Proposal for Supplement 4 to the 03 series of amendments to UN Regulation No. 29 (Cabs of commercial vehicles)

Submitted by the Working Party on Passive Safety*

Supplement 4 to the 03 series of amendments to UN Regulation No. 29 (Cabs of commercial vehicles)

"Figure 1
Front impact test and front pillars impact test
The cab is mounted on the vehicle

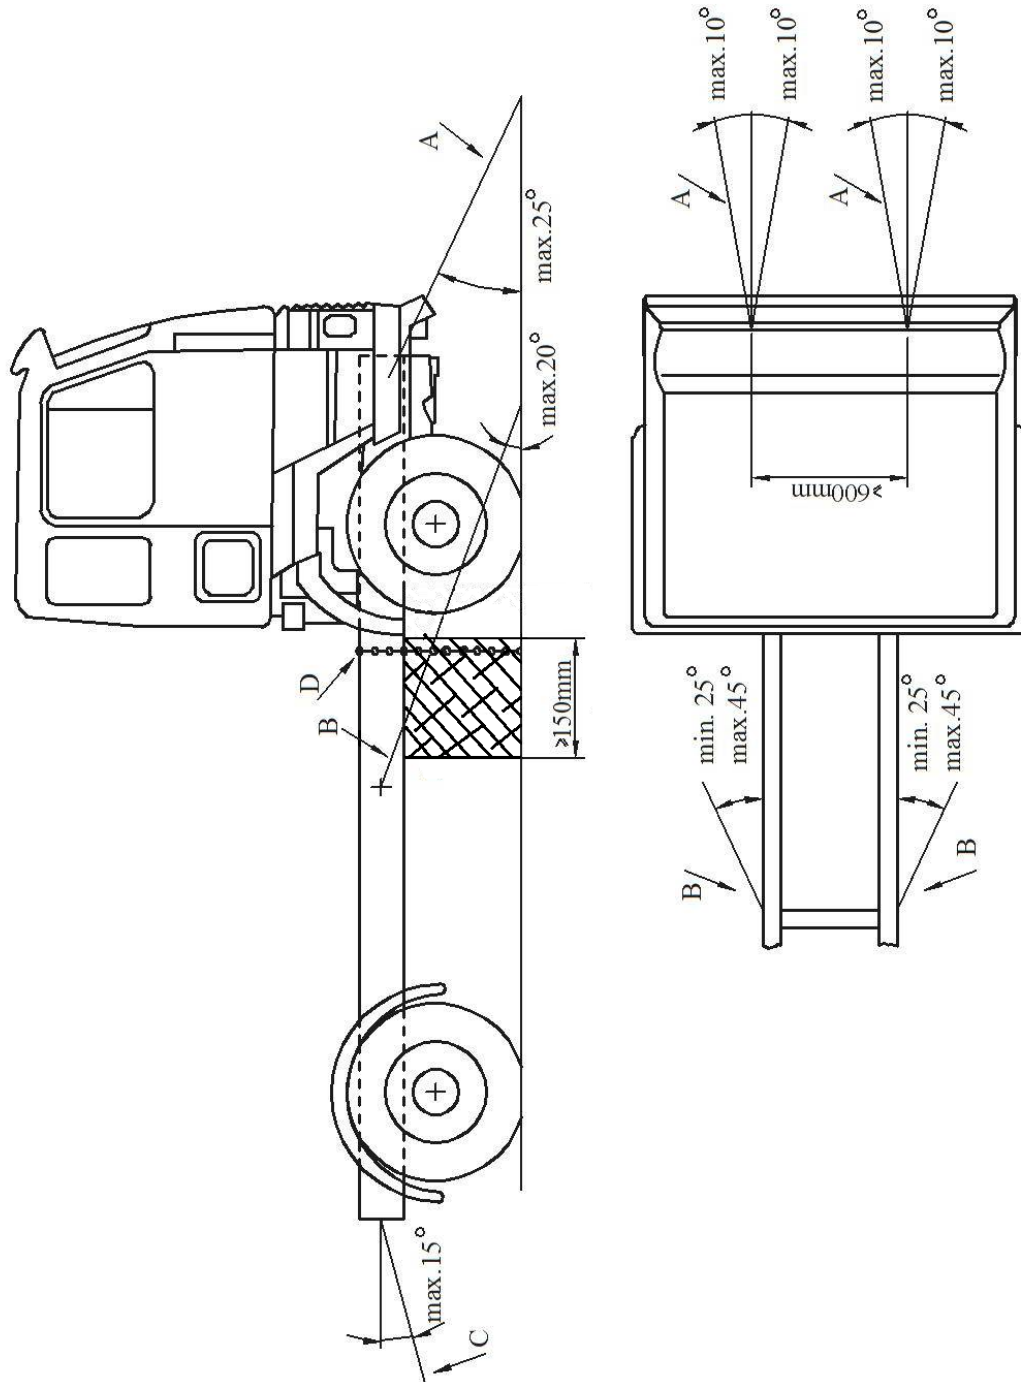
Figure 1, shall be deleted

Insert new Figures 1 and 2, to read:

For tests A and B, the chain or rope C shall, to begin with, be placed under a load of approximately 1 kN. All slack in the four chains or ropes A and B shall then be taken up and chain or rope C shall be subjected to a tensile stress of not less than 10 kN. The angle of chain or rope C with the horizontal shall not exceed 15°. A vertical blocking force of not less than 500 N shall be

applied at point D between the chassis frame and the ground (see Figure 1 below). For test C, the chains or ropes B as described above shall be replaced by the chains or ropes E and F (see Figure 2 below).

Lateral movement shall be limited by chains or ropes B attached to the chassis frame symmetrically in relation to its longitudinal axis. The points of attachment to the chassis shall be not more than 5 m and not less than 3 m from the front of the vehicle. The chains or ropes shall when tensioned form a downward angle of not more than 20° with the horizontal and their projection on a horizontal plane shall form an angle of not less than 25° and not more than 45° with the longitudinal axis of the vehicle (see Figure 1 below).
 - 2.2. Cab mounted on a frame
